Re: Shops @ the 24s

2424 Louisiana Blvd NE Grading and Drainage Plan

Engineer's Stamp dated: 9/11/2018 (H19D001)

The Shops @ the 24's Drainage Analysis Report

Designed: CP/DH Drawn: DER, CP Checked: DMG
Scale: AS SHOWN Date: 9/7/2018 Job: A18018
Sheet C2 of 4

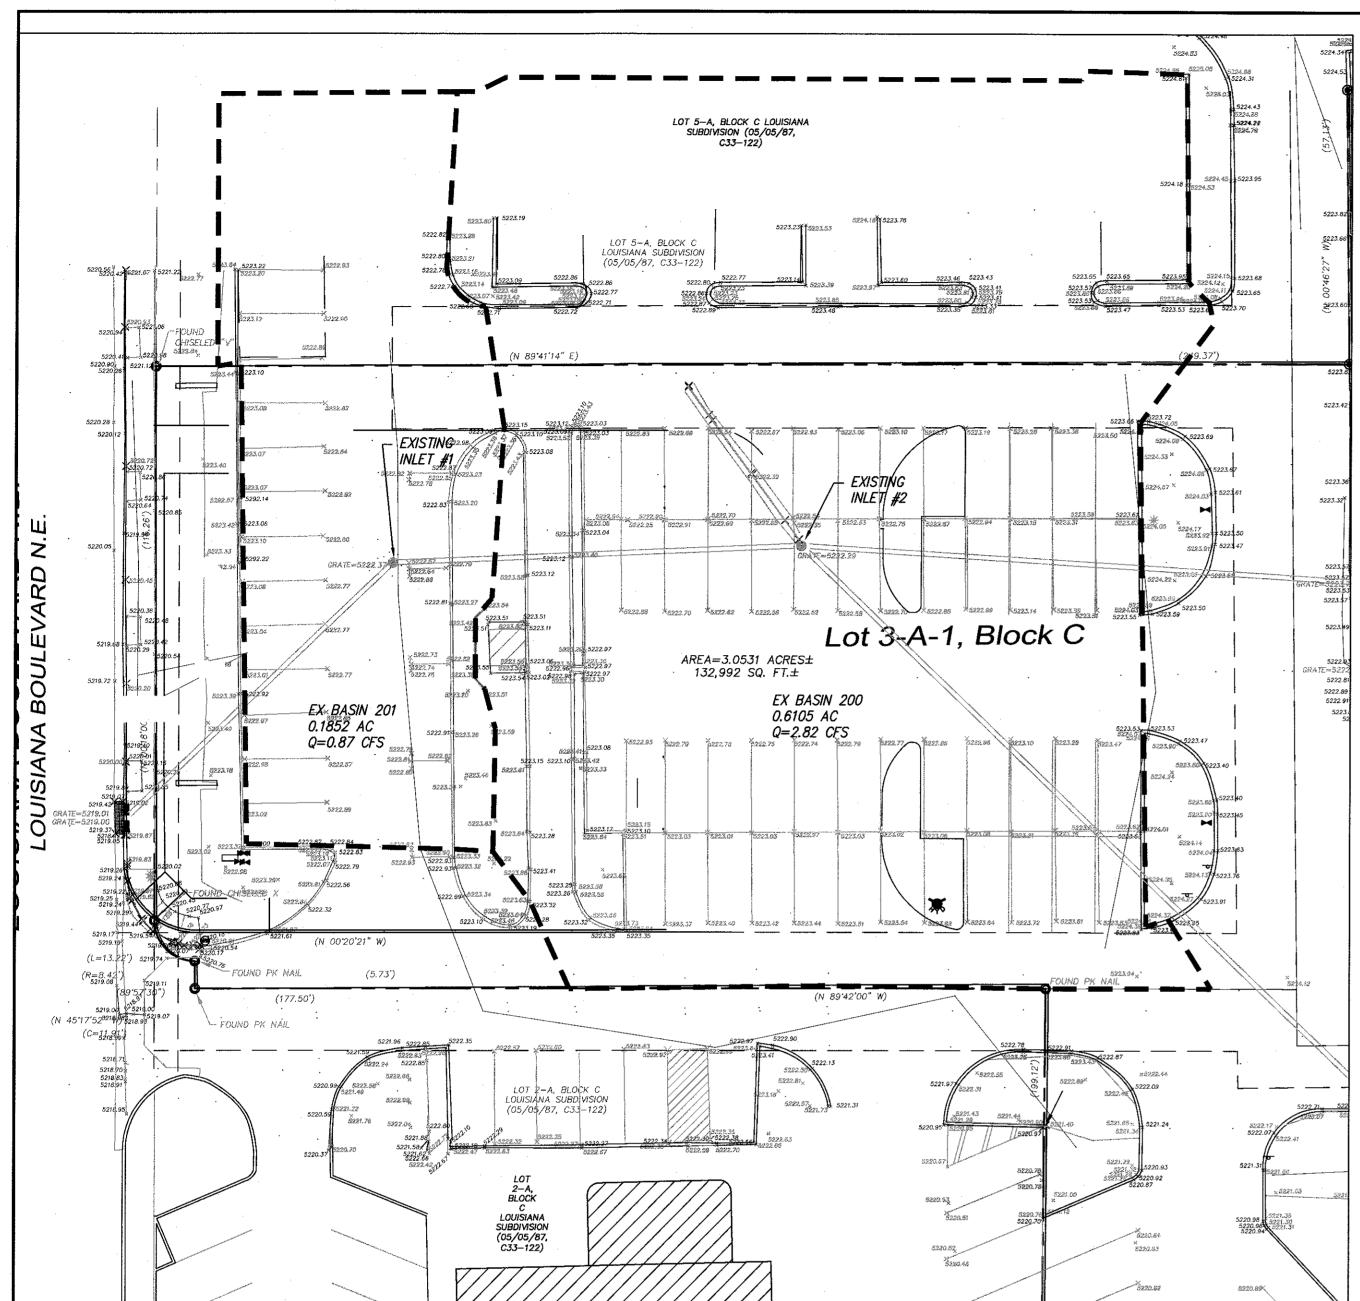
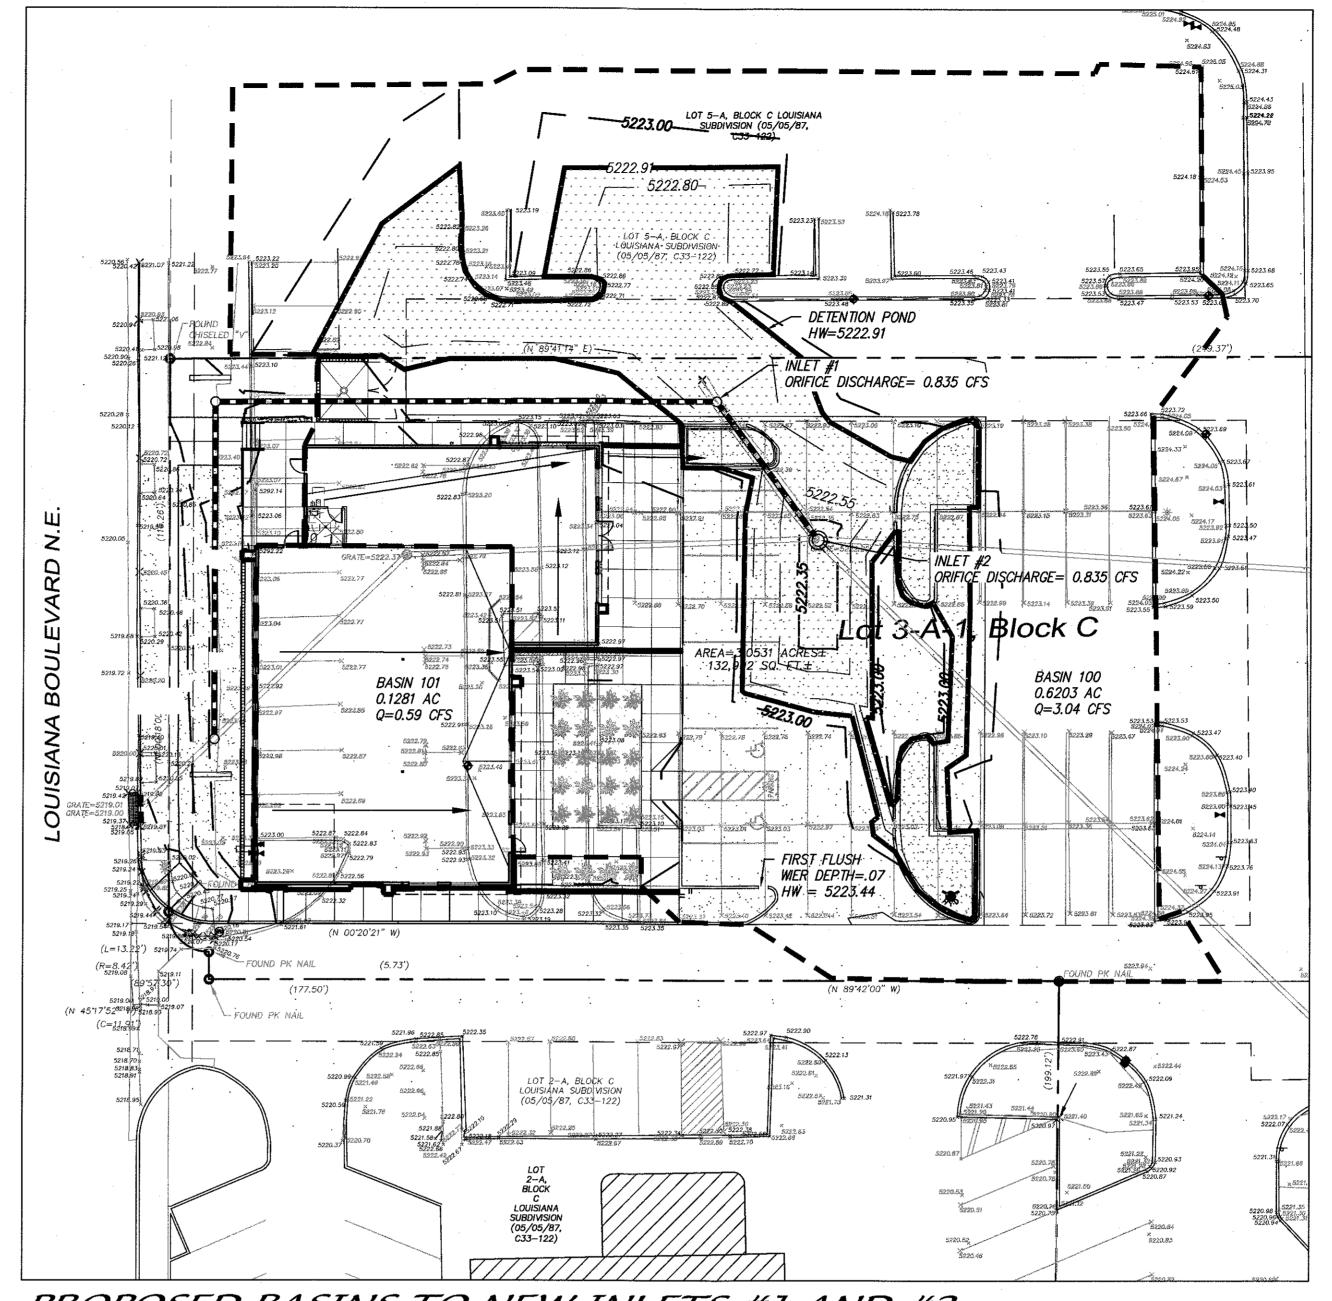
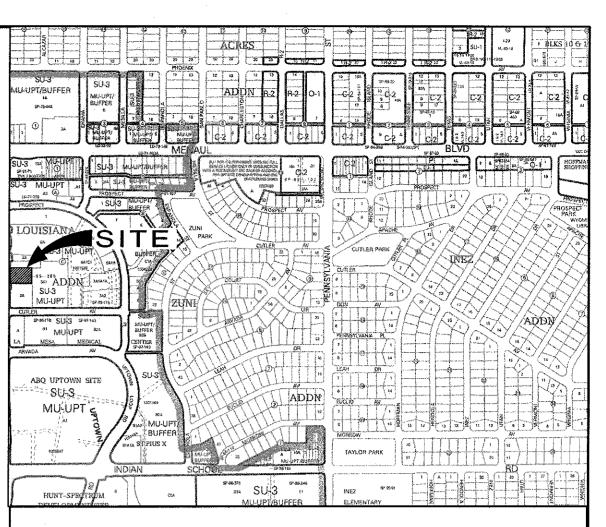
- 1. Add a general statement of the Drainage History to the G&D Plan. The history should mention that this 3.05 acre site was approved in about 1978 for one building with runoff detained on the roof, and asphalt parking lots on the west, south, and east sides of the building also used to detain runoff. Recently the parking lot on the east side of the existing building was converted into an underground parking lot and the detention there was replaced by retention. Two existing parking lot ponds on the south side of the existing building drain to sump inlets with 6" diameter orifice plates located 2" below the surface of the grates. The three existing parking lot ponds on the west side of the building have fallen into a state of disrepair the east inlet orifice plate has become loose inside the inlet, the middle inlet has been modified and the orifice plate is missing, and the west inlet orifice plate rusted through. The three inlets on the west side of the building are of a different type than the two on the south but they seem to have about the same capacity.

- 2. The Drainage Management Plan should say that this project will repair/replace the ponds on the west side of the existing building so that the detained volume will be equal to or greater than that originally planned and the runoff rate will be equal to or less than that originally planned. The Management Plan and History should show up on both the G&D Plan and on the Maintenance Covenant.

- 1. A general statement of the Drainage History is added to the Drainage Plan.
- 2. The Drainage Management Plan says that this project reduces flow from existing discharge rates by ponding water shed of the basins affected with replacement of the inlets with inlets similar to the existing inlets to the south of the existing building. It indicates that the new construction will reduce discharge and restore the original intent of the design and mitigate the developed discharge to an assumed undeveloped discharge with 50%A and 50%B land treatment (Basins 300 and 301).

- 10. The finish contours used in the AYHMO pond routing input are now included in the proposed drainage basins map up to contour 5223.
- 11. The ponds were revised and bottom of ponds 1&2 is now elevation 5222.55 which is shown on the grading plan. The first flush elevation of 5222.75 is at or near the back of curb in ponds 1&2. Contour 5223 and 5222.35 is shown in the parking lot to define the pond. A separate sheet is now included to depict First Flush basins of each first flush pond. Pond #2 (and #1)is a First Flush pond that also contributes to the parking lot detention pond. The pond retains water to elevation 5222.75 (the First Flush elevation) then is submerged by the detention pond up to elevation 5222.91 during the passage of the 100 yr storm. Pond #3 also provides upper elevation storage for the detention pond. The outlet weir for First Flush pond #4 was evaluated for the passage of the 100 yr storm and a 100 yr elevation was included on the Drainage Plan (Sheet C2) and included on the drainage covenant exhibit.

PROPOSED FIRST FLUSH BASINS

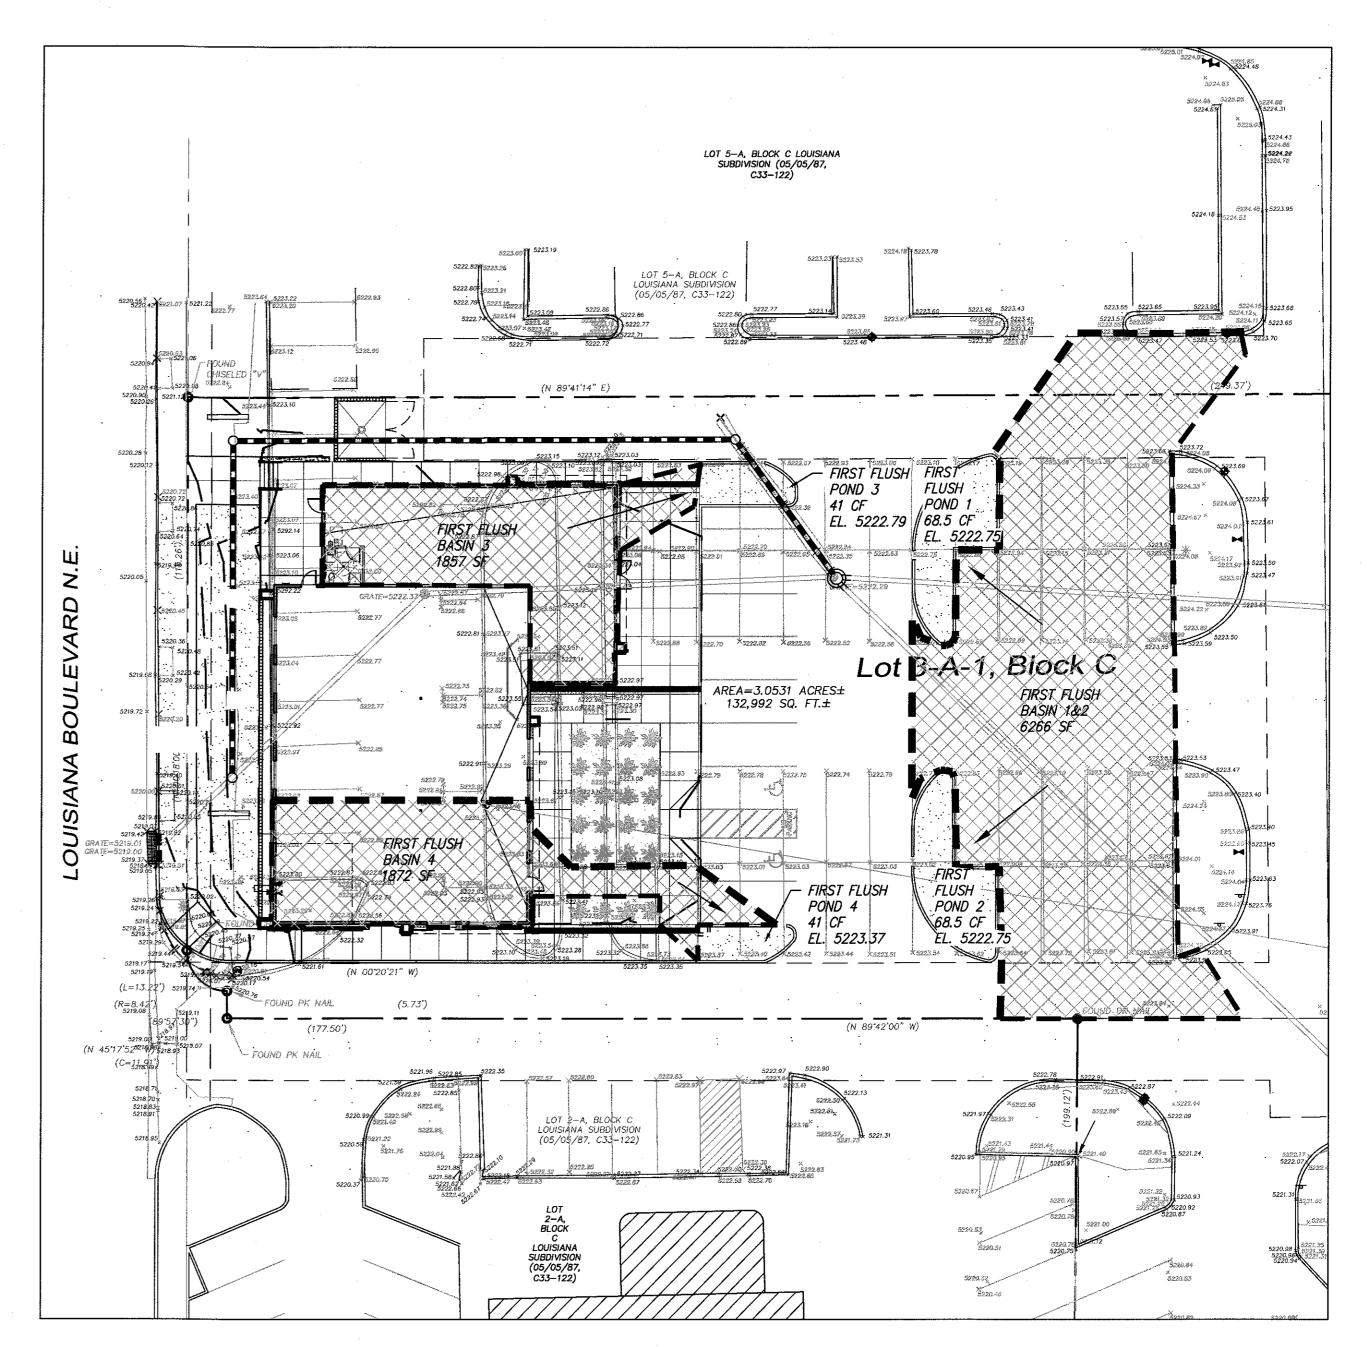
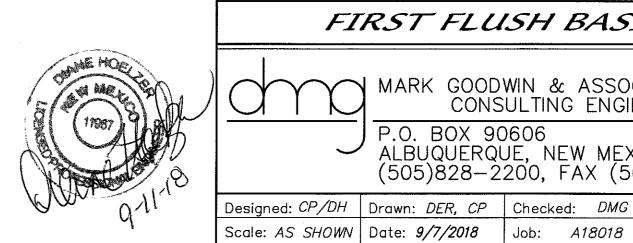
- 12. Clearly identify the area draining into first flush ponds 1, 3, & 4. What portion of the roof drains into each? Show contours and sections thru the edge of each pond and a section thru the spillway of each pond with weir calculations of 100 year elevation on the G&D Plan. Label both the 100 year and first flush elevation of each pond on the G&D Plan and on the Maintenance Covenant.

- 12. An additional sheet is included that shows the first flush basins.
